Product / Process Change Notification (PCN)

PCN #: PCN_WL-SMCD-20200717

Affected Series: 150060xx55040

Image: Substrate of the Chip LED

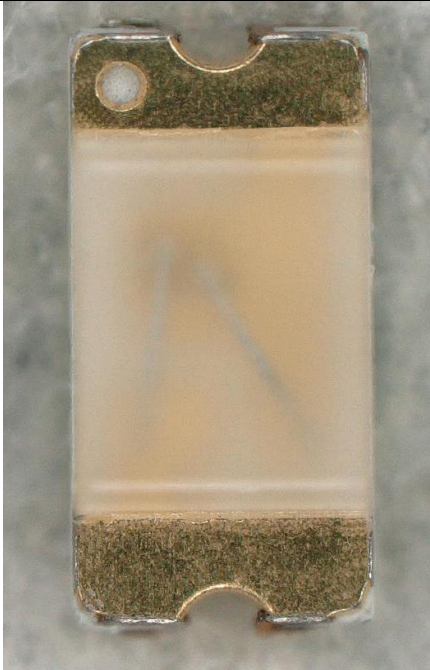
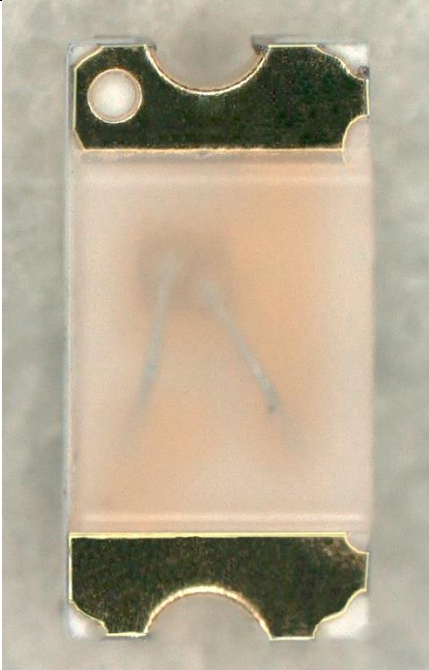
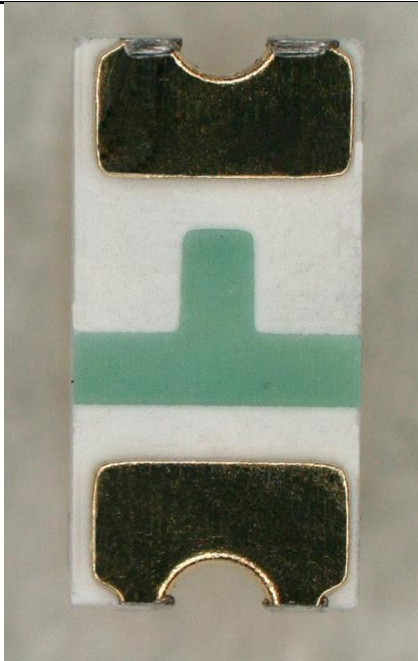
The color of substrates and the contact's form are slightly different. These changes do not impact on the function of the component.
